Chichester Southern Access Road

Chichester Southern Access Road Review

November 2022

Figure 4-1: The Influence of Visibility on Vehicular Speeds (MfS)

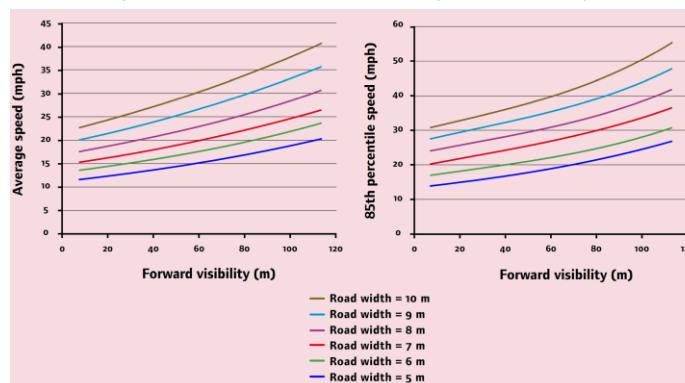
4.4.5 Evidence set out within MfS and reproduced in Figure 4-1 below, suggests that as visibility increases, so do vehicular speeds and was also found to be applicable to junctions. This is particularly important in the context of the design of the Bishop Luffa School roundabout.

4.4.6 Excessive visibility splays have been shown to support higher approach speeds and therefore contribute to increase levels of fail to stop/give way and shunt collisions at or approaching junctions.

Figure 4-3: Uncontrolled Crossings

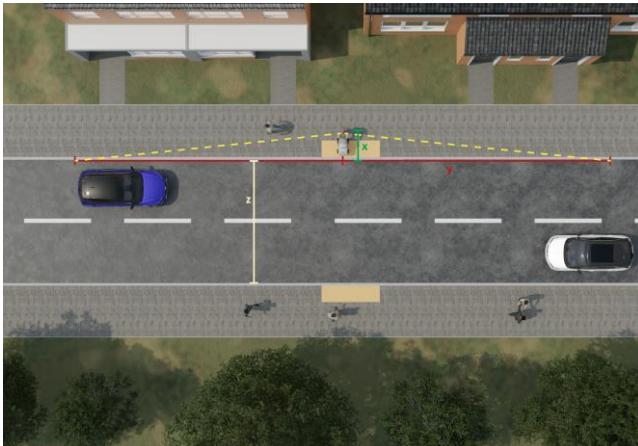
- 4.6.5 In practice a pedestrian will need to observe a gap to cross before making the decision to cross, requiring greater visibility from the crossing position – depicted in Figure 4-3. In MfS the driver hazard reaction time is 1.5 seconds.

- 4.6.6 Where the alignment of proposals considers uncontrolled crossings particularly where these are close to bends or junctions, with/without a refuge, the Transport Assessment should consider flows and approach speeds to inform the need to either reduce traffic flows or propose controlled crossings.
